JUNEAU POLICE DEPARTMENT (JPD) FENCE REINFORCEMENT MATERIAL INSTALLATION Contract No. MR BE20-261

ADDENDUM NO.: TWO

DATE ADDENDUM ISSUED: May 15, 2020

- **Installation Site** Pictured- Below

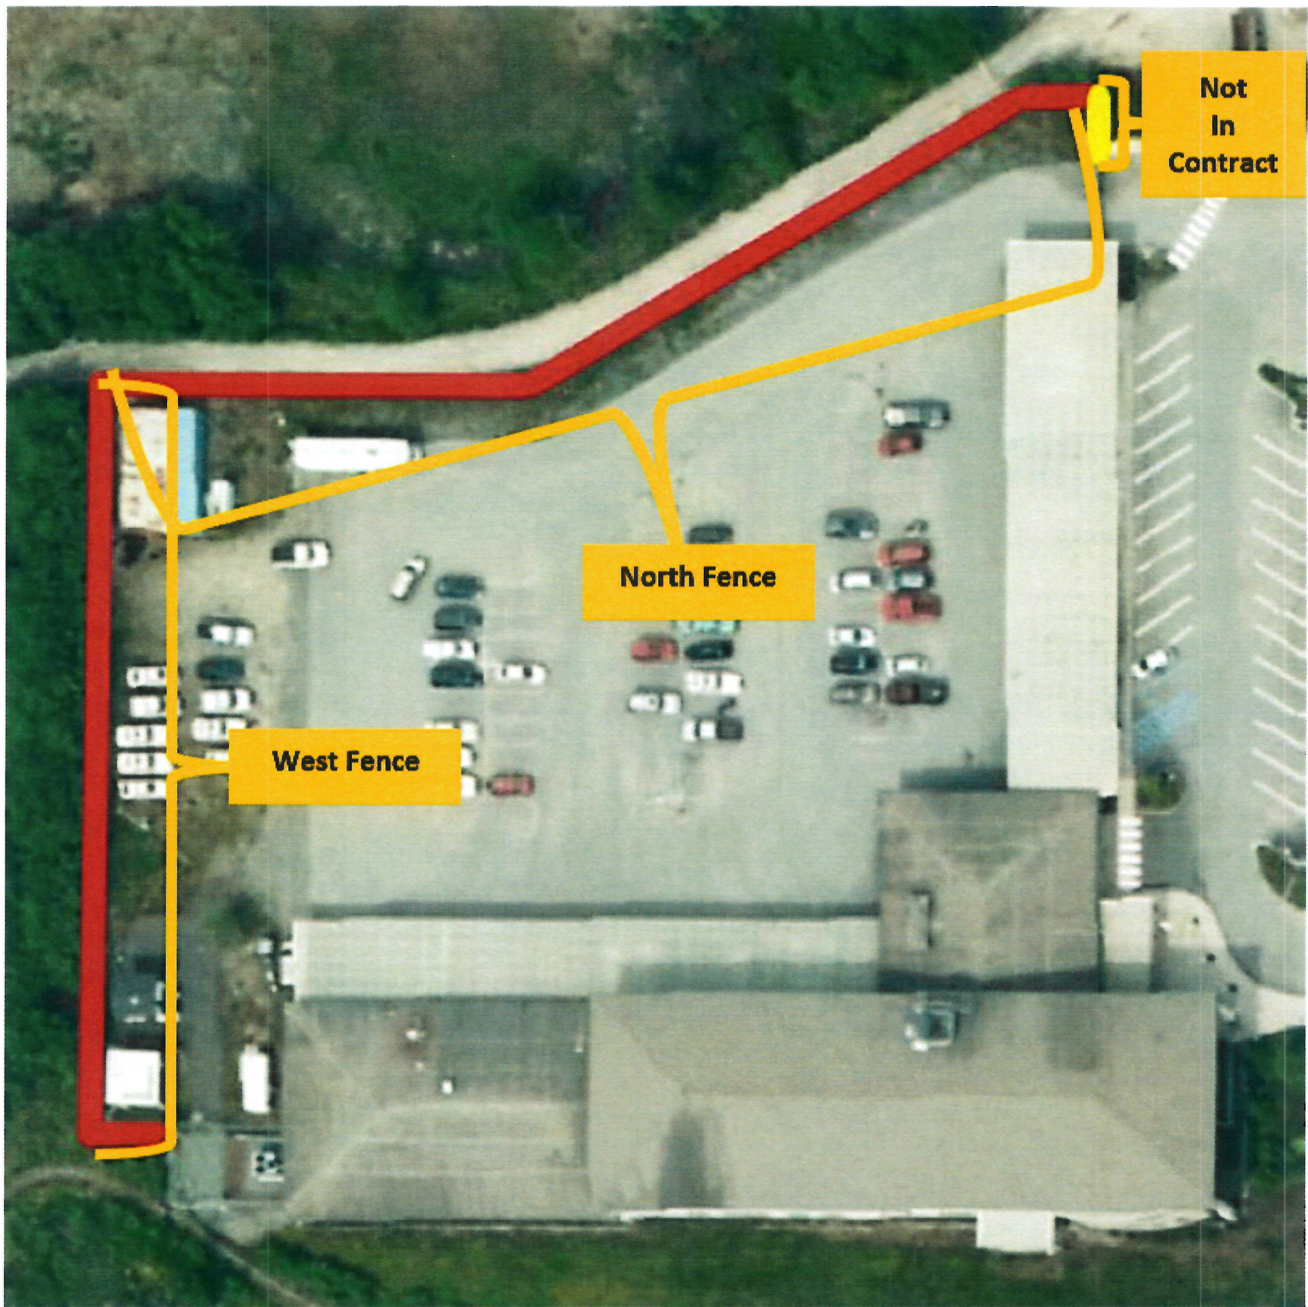
Add the attached West and North Fence Details and overhead photo that provides labels for each fence run.

North Fence Detail

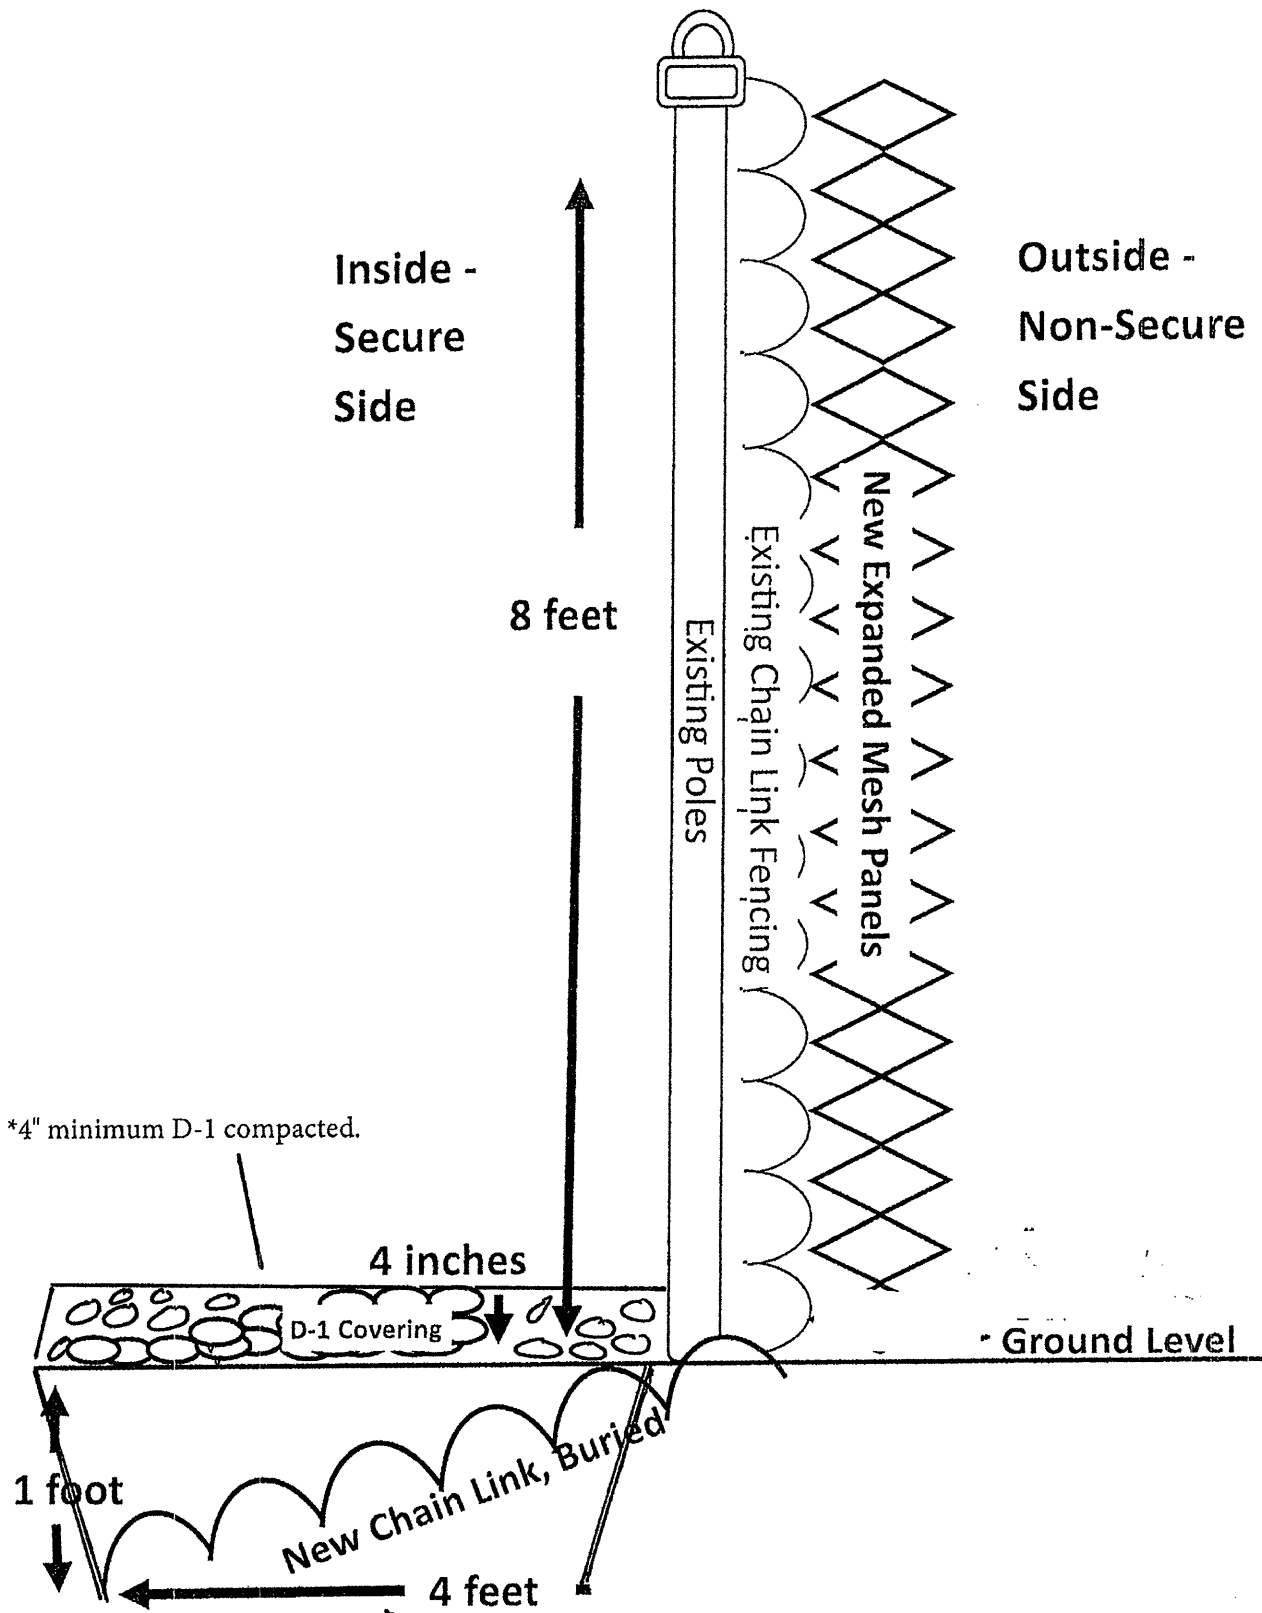
Response: The buried chain link fence is to be buried inside the secure side of the north fence, and outside the secure side of the west fence. See Item nos. 2 and 3, below.

Response: The trenching and chain link burial is on inside of the secure area for the north fence, and outside the secure area for the west fence. If trees pose a problem, contractor shall use appropriate means and methods for trenching outside the west fence. Expanded mesh metal panels are to be installed outside both the north and west fences. See Item nos. 2 and 3, below.

- Buried chain link fence will be attached to bottom trim of existing fence, *extending outside 4' (feet feet) on the west fence and inside 4' (four feet) on the north fence*, and be at least 12" (twelve inches) beneath ground level at the farthest point away from the existing fence.

- D-1 will cover the buried fencing material at least 4" above the existing ground level.
 - The D-1 covering will be compacted with a plate compactor.
